**SUBDIVISION &  
ZONING AMENDMENT STAFF REPORT****Date: April 21, 2016****APPLICANT NAME**

Gulf City Body &amp; Trailer Works, Inc.

Gulf City South Subdivision

Subdivision Approval to create a single legal lot of record from an existing metes-and-bounds parcel; and Rezoning from I-1, Light Industry District, to I-2, Heavy Industry District, to allow a steel service facility.

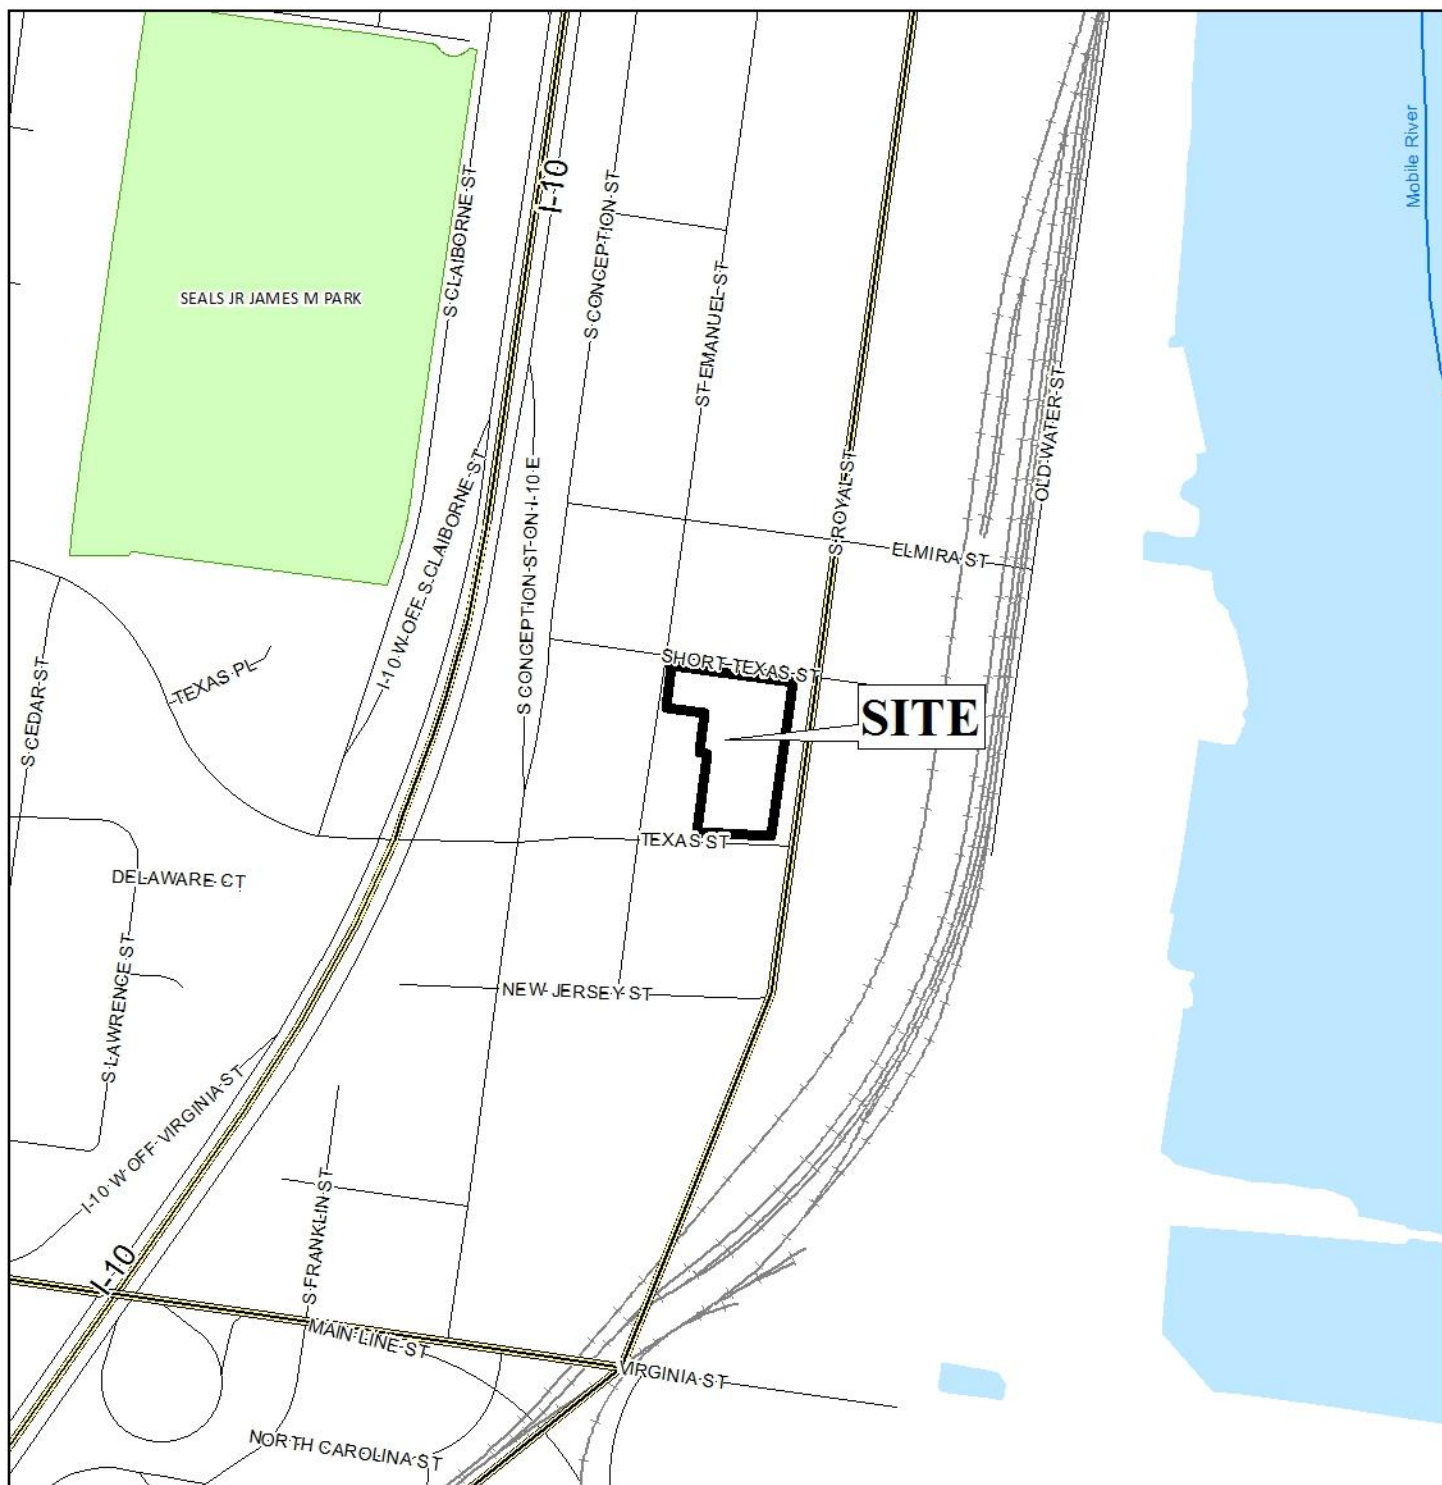
- B. Add legible street names to the vicinity map.
- C. Review the interior angles listed on the plan and in the written legal description. One of them appears to be an exterior angle.

- D. Revise the plat to label each lot with its size in acres and square feet, or the furnishing of a table on the Plat providing the same information.

- E. Show and label all flood zones.
- F. Show and label the MFFE (Minimum Finished Floor Elevation) on each lot that contains an AE, V, or X (shaded) flood zone designation.

- G. Provide and label the monument set or found at each subdivision corner. Include witness monuments for the corner(s) where a monument cannot be set.

*The proposed lot meets the minimum size requirements of Section V.D.2. of the Subdivision Regulations. The lot is not labeled on the plat with its size; therefore, the plat should be revised to label the lot with its size in both square feet and acres, after any required dedication, or a table should be furnished on the Final Plat providing the same information.*

- 1) revision of the plat to label the lot with its size in both square feet and acres, after any required dedications, or the furnishing of a table on the Final Plat providing the same information;*

- 2) revision of the plat to provide a 25' corner radius dedication at all public street corners;*
- 3) retention of the 25' minimum building setback line along Short Texas Street and the 20' minimum building setback line along all other street frontages;*

# SITE PLAN

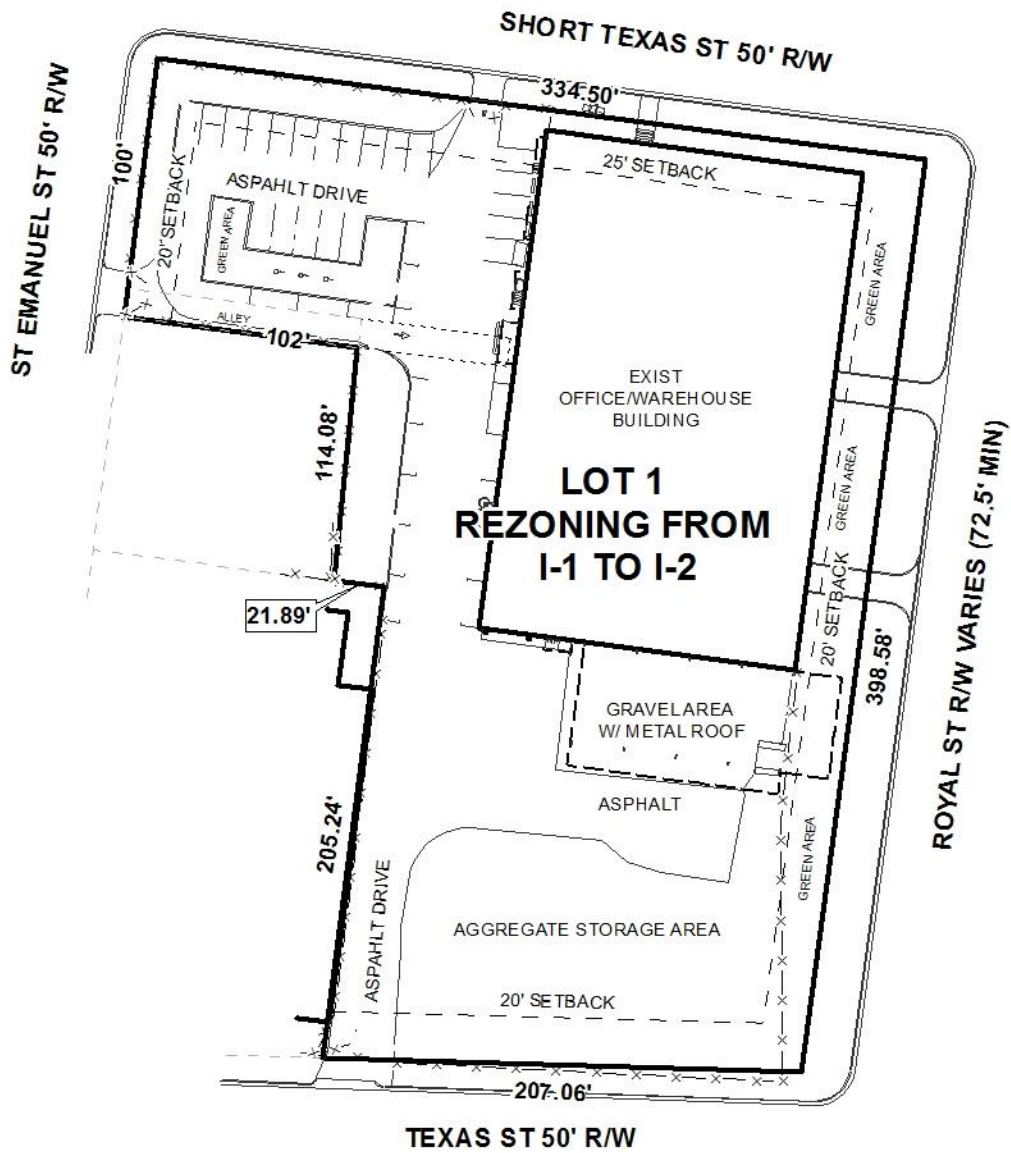
The legal description for the site is metes-and-bounds; therefore, a pre-1952 legal description should be provided or a one-lot Subdivision application submitted to make the site one legal lot of record. A discrepancy has been noted by staff in that the site plan indicates South Royal Street to have a current 64’ right-of-way and City GIS indicates approximately a 90’ right-of-way for South Royal Street along the site’s frontage. In that the Major Street Plan requires an 80’ right-of-way for South Royal Street along the site frontage, there may be the possibility that dedication would be required to provide 40’ from the centerline of South Royal Street. It should be noted that the City GIS indicates the right-of-way wider along the West side of South Royal Street within this block, the block due South, and approximately half-way up the block to the North for what was a railroad spur track. Therefore, this discrepancy should be accounted for.

The legal description provided seems to have an error in that the Point of Beginning is at the Southwest corner of Royal Street and Texas Street as opposed to the Northwest corner of that intersection. Therefore, the legal description should be reviewed and corrected. Also, the legal description indicates the 12.5' alley running from St. Emanuel Street is not part of the site, but it is enclosed within the fence surrounding the site. Therefore, the legal description should either be corrected to account for the inclusion of the alley into the site or the site plan should be revised to relocate the fence to the North and East sides of the alley and restrict any site access to the alley.

The site plan indicates areas with parallel parking spaces in which the interior spaces scale to be 20' long. As 23' is the required minimum length for interior parallel parking spaces, the site plan should be revised to provide such.

- 3) verification of the right-of-way width of South Royal Street along the site frontage and revision of the site plan to depict additional setback in lieu of dedication to be measured from 40' from the centerline of South Royal Street, in compliance with the Major Street Plan;

- 4) verification of and correction of (if necessary) the Point of Beginning of the legal description of the site;
- 5) correction of the legal description to account for the inclusion of the alley from St. Emanuel Street within the site enclosure on the site plan, or revision of the site plan to relocate the site enclosure to the North and East boundaries of the alley and restrict any site access to the alley; and

- 6) revision of the interior parallel parking spaces to a minimum 23' length.
